Michael Manser Associates
 8 Hammersmith Broadway London W6 7AL 01-741 4381

contract
 38+40 ETON AVENUE
 LONDON NW3

drawing
 PROPOSED THIRD FLOOR+GALLERY PLANS

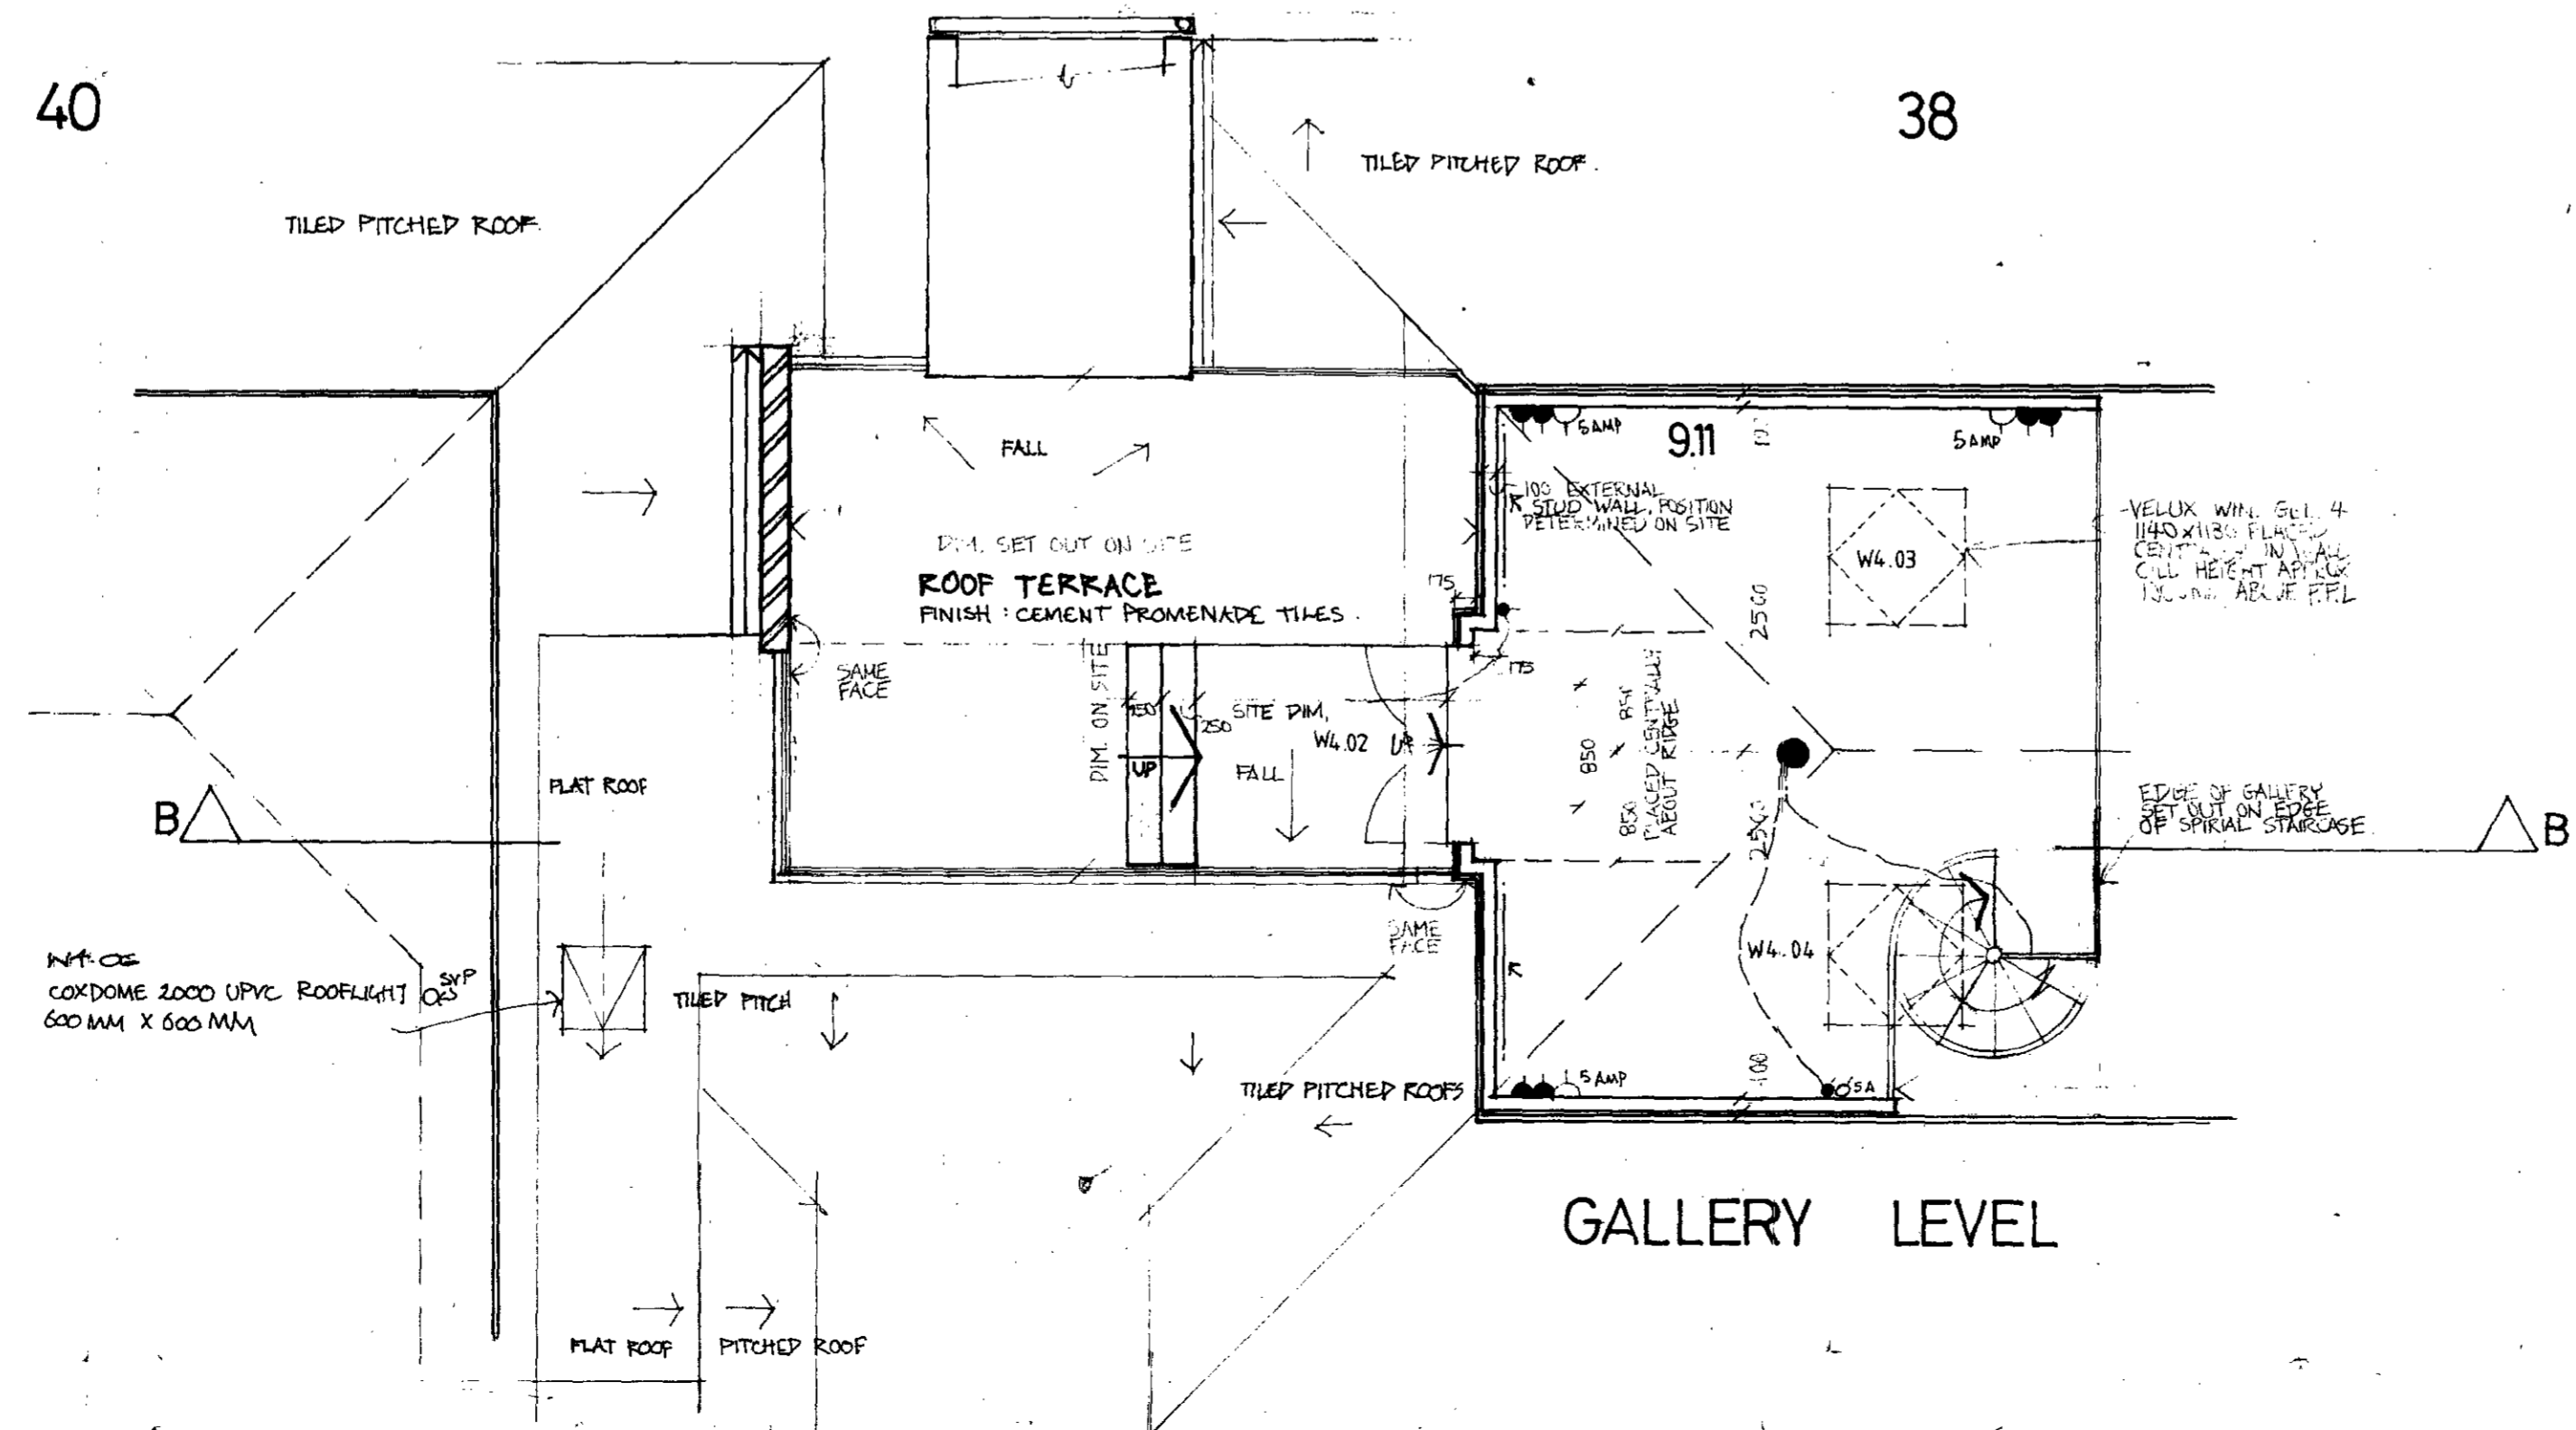
- F. 6. 10. 10. 5.
- POSITION OF ELECTRICAL SUPPLY BOX ADDED
 - NEW LEFT FLANKING WALL TO CENTRAL CORE CHANGED FROM A CAVITY WALL TO 9" BRICK POSITION OF GUTTERS SHOWN - DETAILS KEPT IN

- FACE OF W3.3 CHANGED SO AS BALCONY IS OPEN W3.3 CHANGES FROM A SINGLE GLAZED DOOR WITH SIDE LIGHTS TO A WINDOW
 - 100MM SVF APPLIANCES IN LIFT SHAFT REMOVED - STORAGE RACK FROM BEDROOM 1 NOT ADDED TO BE PICKED UP FROM SVF BELOW

- POSITION OF SUBS IN CENTRAL CORE BRICK ANGLE 27.6 / 10.10.5
 - POSITION OF BOILER SERVICE DUCT ADDED - SIZE OF RADIATORS CORRECTED
 - POSITION OF S.W.S. SHOWN - NOTES ADDED - STEPS ON TO 24-6-85

- ROOF TERRACE ADDED - POSITION OF ROOFLIGHT ACCESS WHICH ADDED
 - IN 10.10.5 DIMENSIONS - NOTES ADDED - LIVING ROOM EXTRA RISER ADDED TO BOTTOM OF SPIRAL STAIRCASE - STEPS AROUND BASE OF STAIRCASE REMOVED

drawing
PROPOSED SECOND FLOOR PLANS

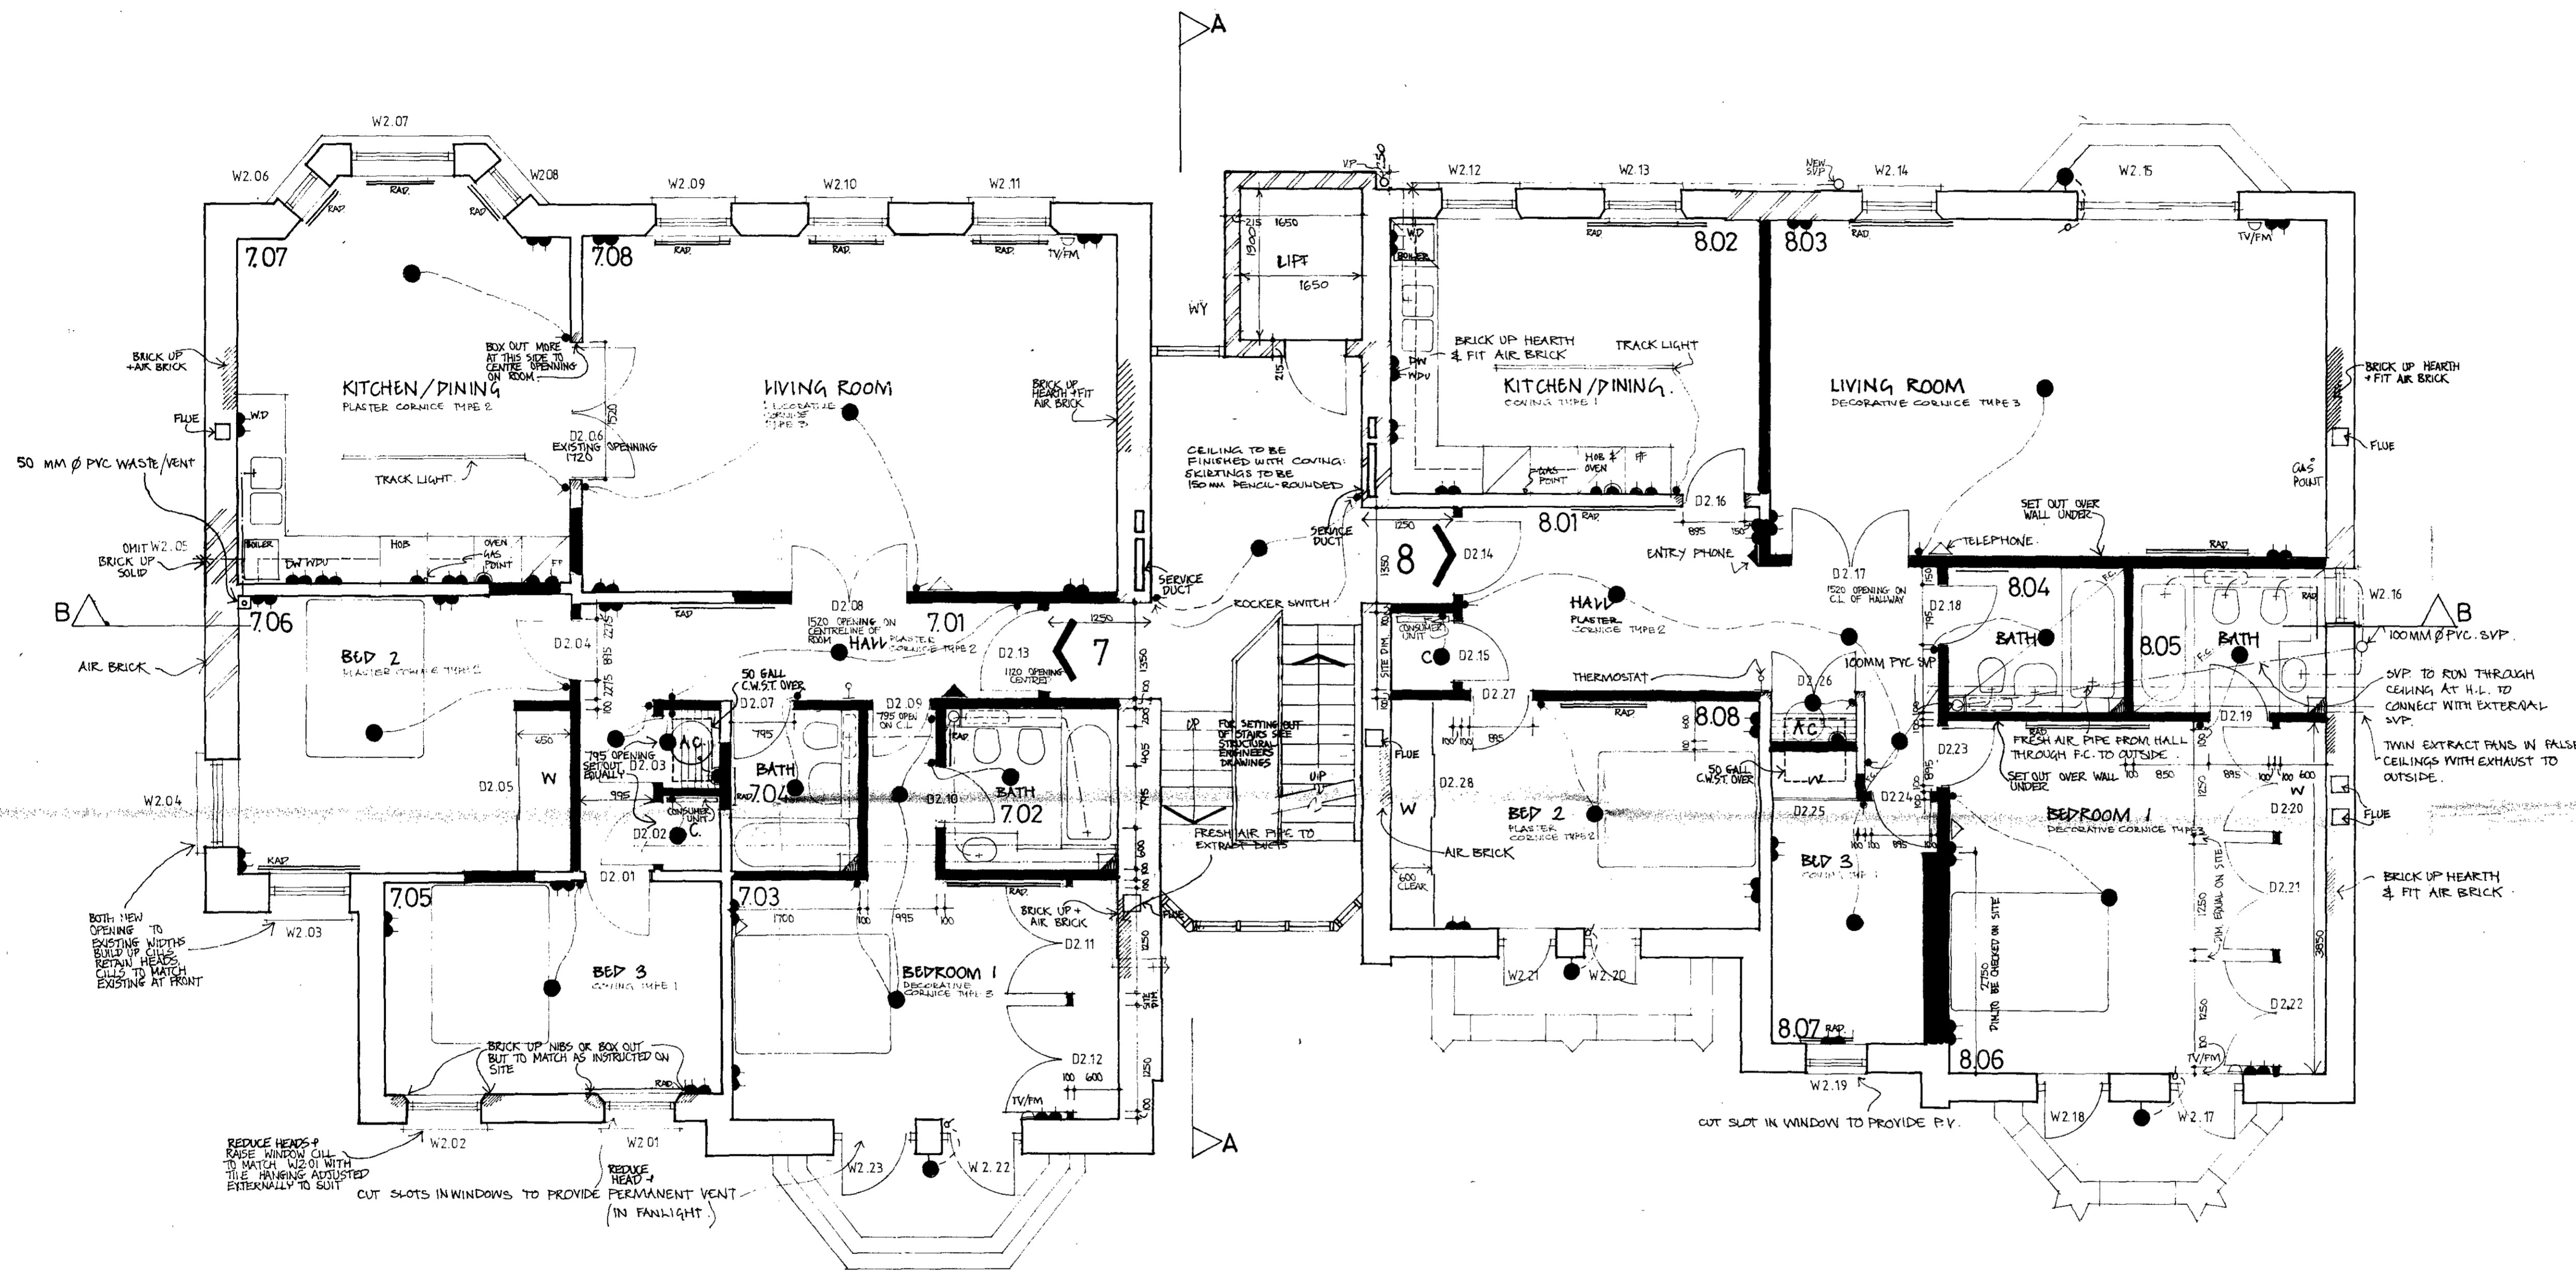
- J POSITION OF SVP ADJACENT TO LIFT SHED MOVED TO THE LEFT OF W2.14 & 50MM PIPE TO KITCHEN SINK CONNECTED & UP ADDED. REAR CHIMNEY BREAST CUT BACK, NOTES & 50MM POINT TO LIFT REMOVED.
- K POSITION OF THERMOSTAT CORRECTED CONCRETE ADDED 140x85
- L 19.6.85 SIZE OF SERVICE DUCTS CORRECTED, 150mm POINT ADDED
- M 6.8.85 POSITION OF RISERS IN CENTRAL HALL SPARE AVENUE? BED 1.
- N USE OF RADATORS CORRECTED IN ACCORDANCE WITH SCHEDULE & POSITIONS OF BOILERS & SERVICE DUCTS ADDED.
- O NOTES & PIPES ADDED, POSITION OF C.W.S.T. SHOWN, 240x400
- P UPDATING OF KITCHEN LAYOUT
- Q 19.6.85 NOTES ADDED, DIMENSIONS ADDED, NOTES REVERSED, BEDROOM 3L RIGHT INTERNAL WALL THICKENED, POSITION OF FLEES ADDED, WINDOW W2.05 OMITTED & OPENING BLOCKED UP.

drawing
PROPOSED GROUND FLOOR PLANS

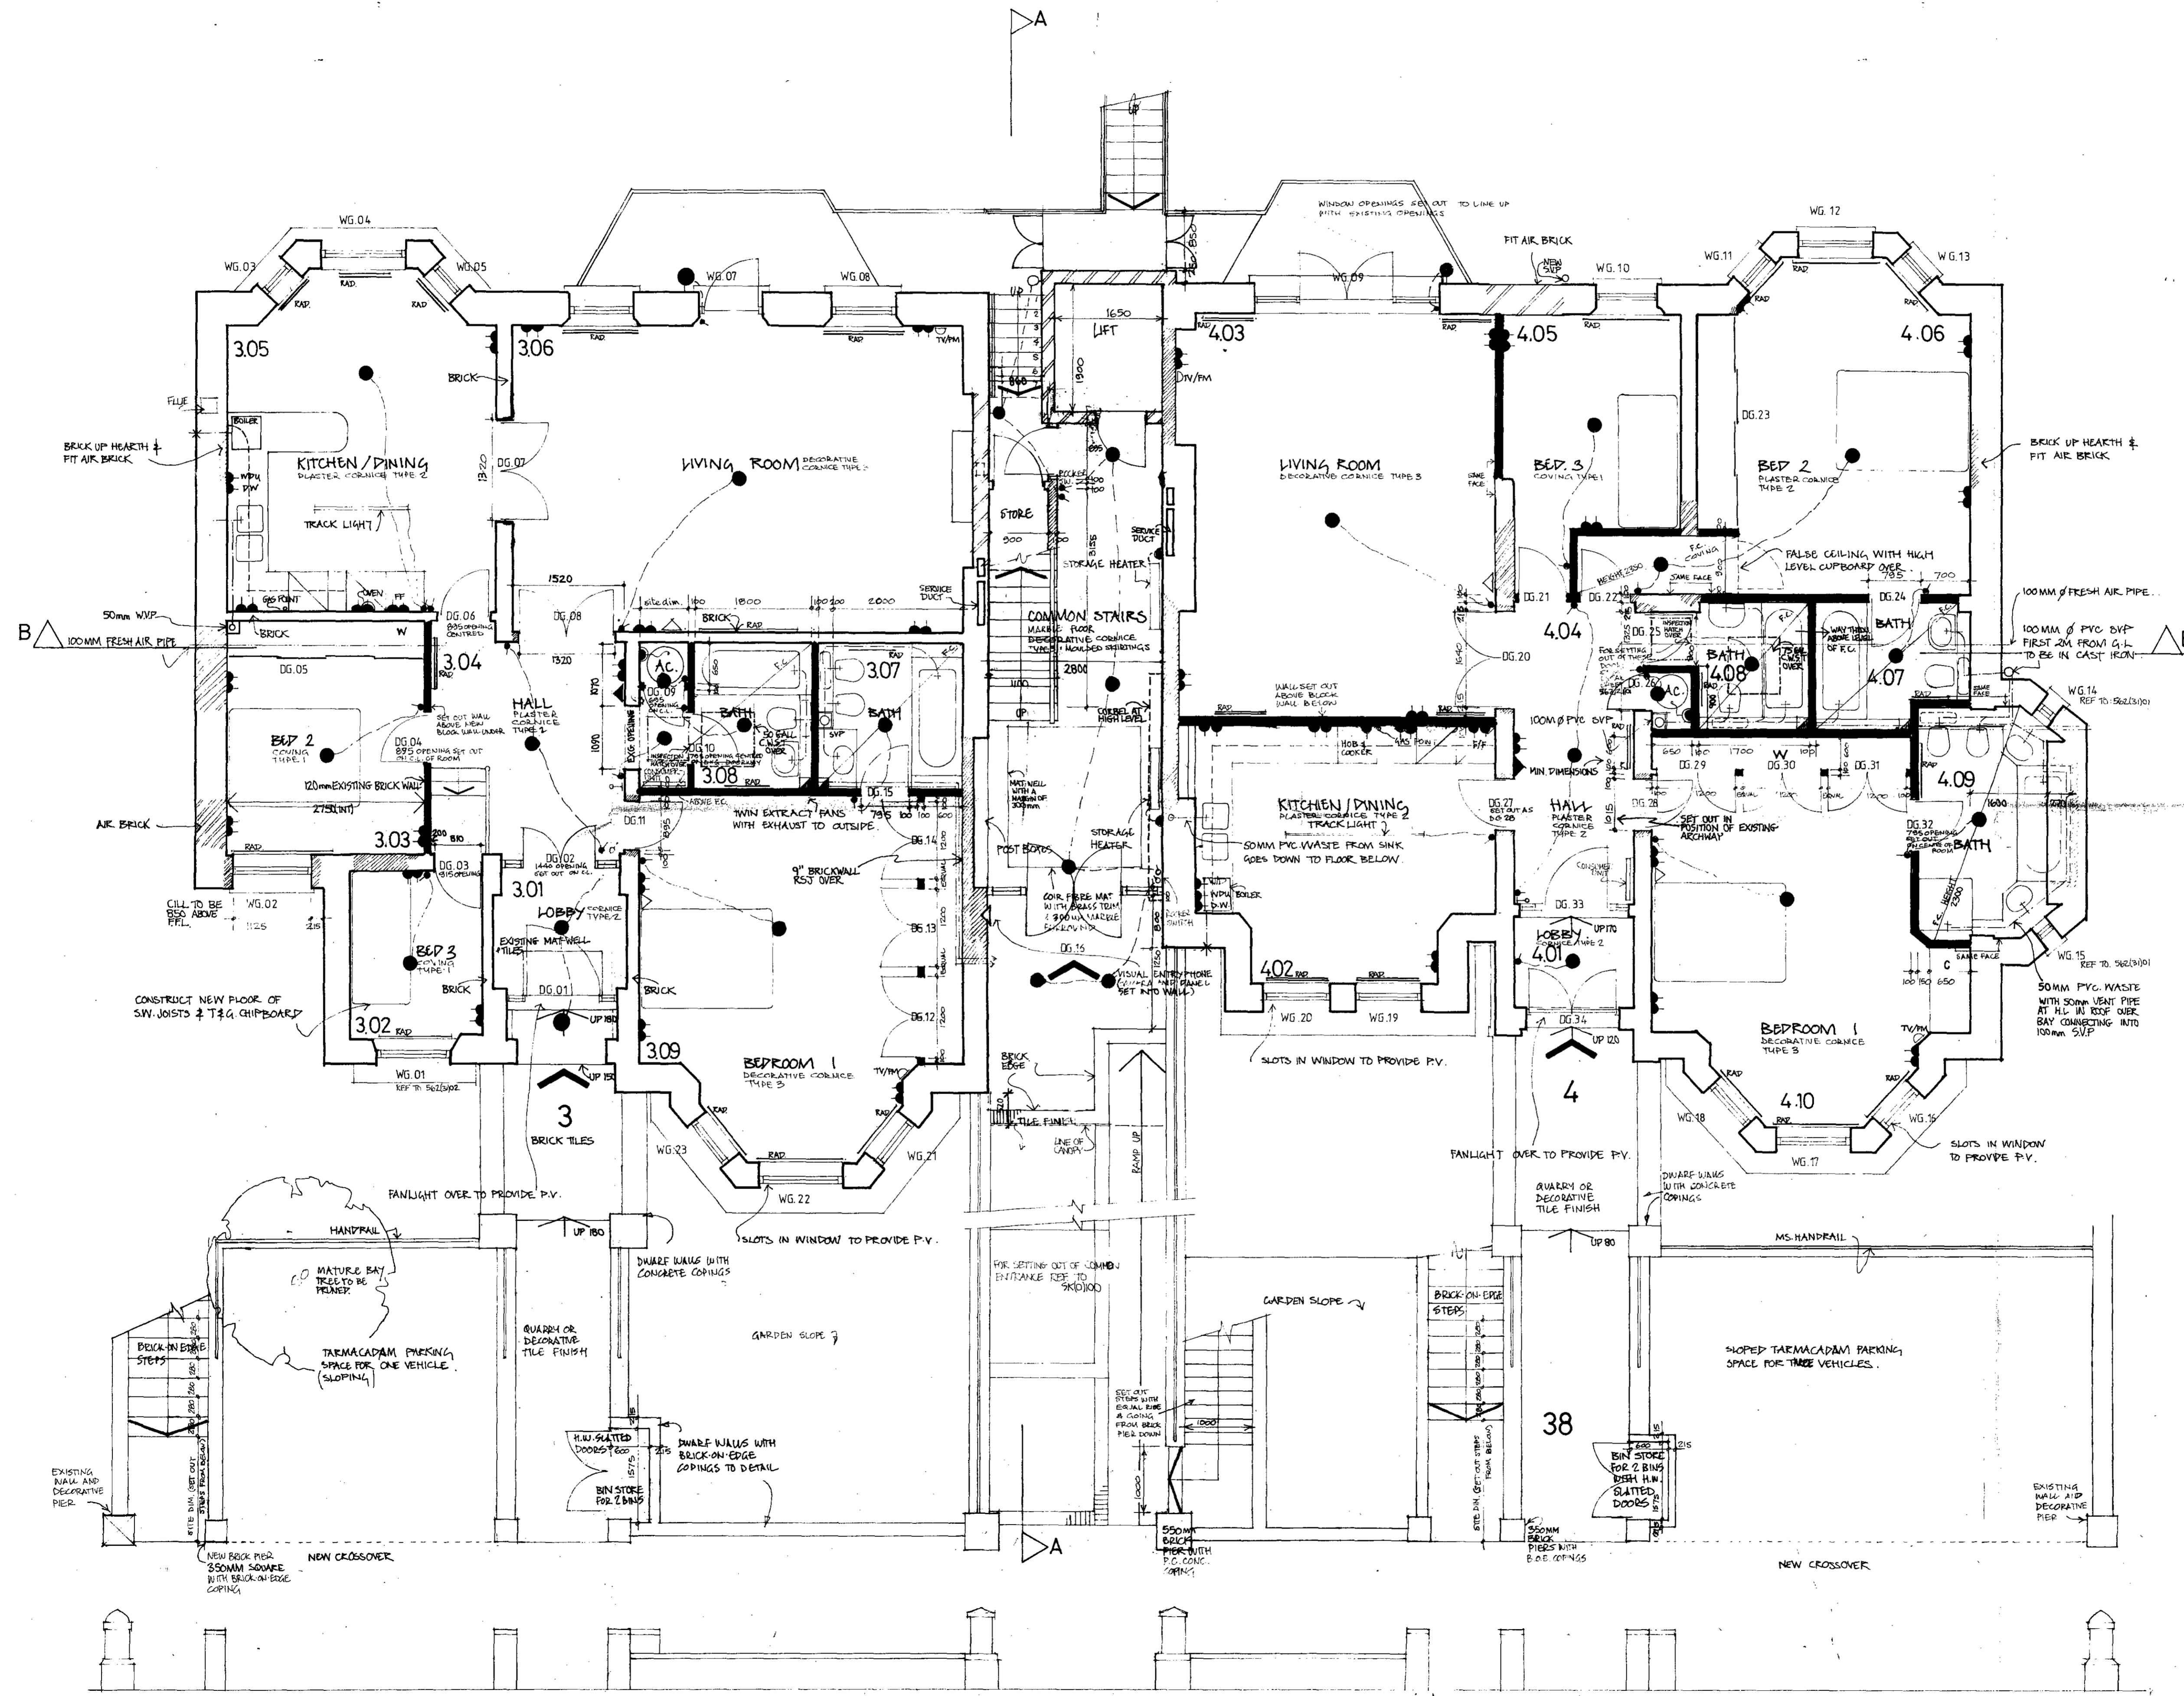
- L GRATES ADDED LEADING BACK TO BALCONY BY WINDOW ROOF REAR CORNER CHIMNEY BREAST REMOVED FROM STAIR
- M POSITION OF THERMOSTATS CORRECTED
- N COMMON ENTRANCE RAMP ALTERED

- O POSITION OF CONSUMER UNITS ADDED
- P NEW SVP APPENDANT TO W.G.10
- Q NOTES ADDED ONE STEP REMOVED OF REAR FLIGHT TO G. LEVEL FALSE CEILING TO LOBBY AREAS REMOVED

- R POSITION OF SERVICE DUCTS ADDED G.P.O. POINT ADDED BED 1 ONE STEP REMOVED OF REAR FLIGHT UP IN ONE AREA
- S ONE STEP ADDED TO CENTRAL CORNER POINT STAIRS

- T POSITION OF INSPECTION HATCHES SHOWN DOTTED 15/8/85
- U POSITIONS OF BOILERS ADDED
- V POSITION OF COMMON STAIRS SLIGHTLY AMENDED 10/8/85
- W POSITION & SIZE OF RADIATORS CORRECTED ACCORDING TO SCHEDULE POSITION OF BOILERS ADDED

- X BALCONIES CUT FROM LIVING RM'S EXTENDED WITH SLOPE OF BAY WHICH BELOW ARE RELEASED HORIZONTALLY TO PROVIDE GARDEN
- Y INTERIOR W.P.V. ADDED POSITION OF WASTE PIPES CORRECTED & PROCESS

- Z LINE OF CORNER INTERNALS AROUND COMMON STAIR HALL
- AA ADDED STEPS LEADING TO ENTRANCES OF FLATS 3&4 ALTERED DIMENSIONS & NOTES ADDED POSITION OF FLOORS ADDED 19/6/85

- AB KITCHEN LAYOUTS ADDED
- AC DIMENSIONS ADDED 14/5/85
- AD CORRIDORS SHOWN 14/5/85
- AE CORRIDORS SHOWN 14/7/85
- AF POSITION OF LIFT & STAIRS ADDED 14/7/85
